<b>Application Number:</b>	<b>AWDM/0163/24</b>	<b>Recommendation - REFUSE</b>
<b>Site:</b>	<b>42 Brighton Road, Lancing</b>	
<b>Proposal:</b>	Demolition of existing dwelling and construction of a 4-bedroom detached dwelling over 3 levels with rear terrace and associated works. New outbuilding with raised terrace to the south. New detached garage with guest bedroom over and cycle store to the north. Application to Vary Condition 1 (approved plans) of previously approved AWDM/0923/21. Amendments: Inclusion of a trellis/privacy screen along the area of terrace next to the sunken seating as part of proposed landscaping scheme	
<b>Applicant:</b>	Mr Mario Bernard	Ward: Widewater
<b>Agent:</b>	Domus Architecture Ltd	
<b>Case Officer:</b>	Peter Barnett

## Update since March 4th Planning Committee

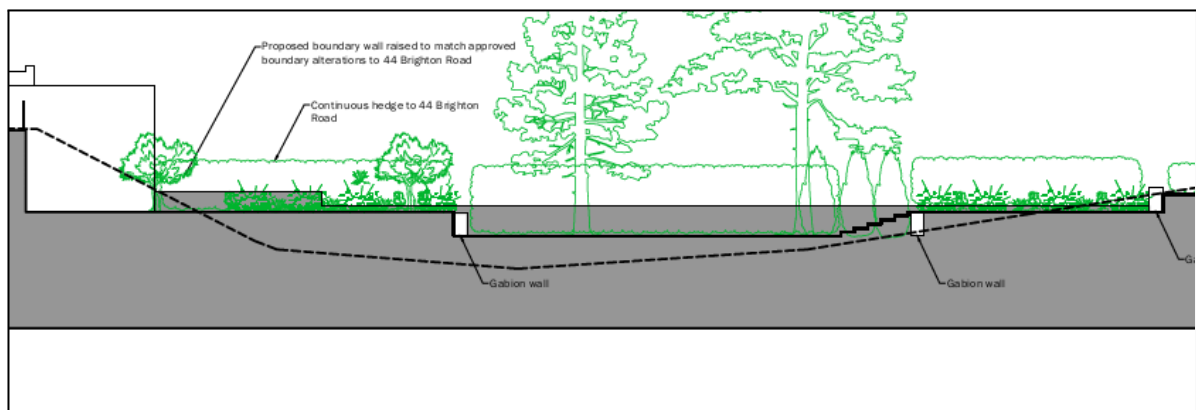
The works that have been carried out were done so without the submission of further details and originally appeared to be far more extensive than originally shown. The images below show the proposed garden levels relative to the boundary wall with 44 Brighton Road to the east. The approved plans suggested that the garden level at No. 42 would sit between 1.3m - 1.7m lower than the top of the wall on the boundary with No.44. However, the wall at No.44 was not built to the height shown on the

original plans and, as a consequence, as constructed, the garden level is almost at the top of the wall, allowing clear views down onto the rear garden and pool at No. 44.

The approved plans were misleading and gave the impression that there would not be significant overlooking of the neighbours' garden. In this respect the approved drawing included a note that the boundary screen would be at the same height as the neighbours when in fact as indicated on the current cross section it is a lot lower. In cases such as this where there is a significant change in levels a planning condition was imposed requiring details of levels to be submitted prior to the commencement of development on site but this condition was not discharged prior to the rear terrace being formed.

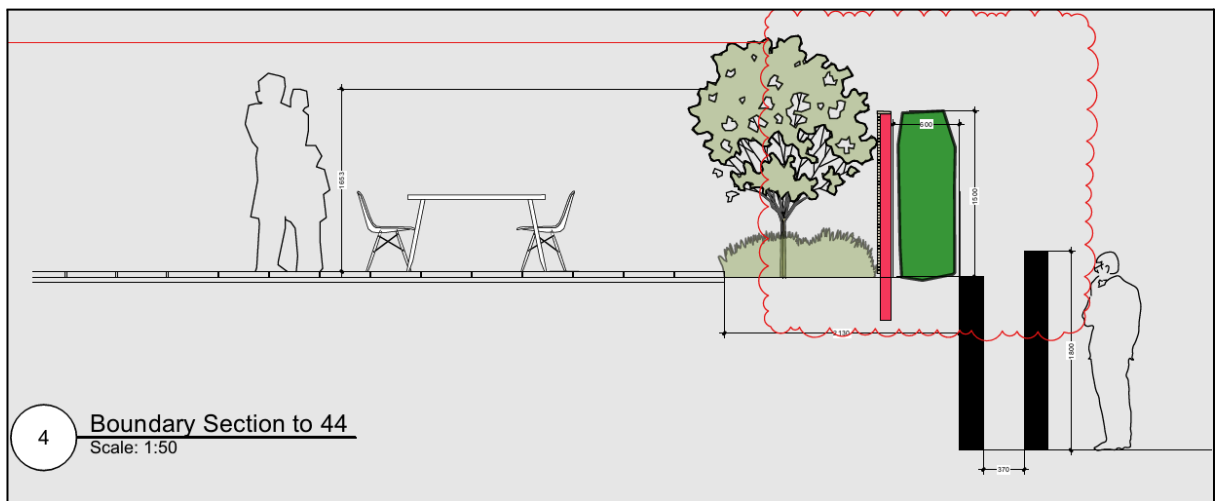
The rear garden and the changes to the ground levels has resulted in the greatest impact to neighbours, particularly the occupiers of No.44 to the east. That property underwent its own development recently which included changes to ground levels and the construction of new boundary walls. However, the changes to the rear garden level at No.42 has resulted in an increase in the height of the garden, particularly in the area adjacent to the rear of the house where it is possible to stand at almost the same height as the top of the boundary wall with clear views down onto the neighbours' patio and pool area.

The plans for the rear garden of No. 42 show a sunken seating area close to the boundary with an outdoor dining area on higher ground beyond that. There is a swimming pool on the west side of the garden. The garden then steps down to a lower central area before stepping up again to a garden room and pergola at the end of the garden.

The landscaping plans show a new hedge being planted along the boundary with a new 1.5m high trellis and then an area of landscape planting between the raised dining area and the boundary to prevent people from standing right up to the boundary.

The concerns and objections of the adjoining residents are understandable as the raising of the garden level has resulted in significant overlooking. While the landscaping scheme proposed, including new hedge planting and trellis, will provide some mitigation in overlooking the disparity in ground levels between 42 and 44 is such that any structures or planting on the higher ground will increase the overbearing nature of the development and a reduction in ground level in the area around the sunken patio on the boundary with No. 44 is essential.
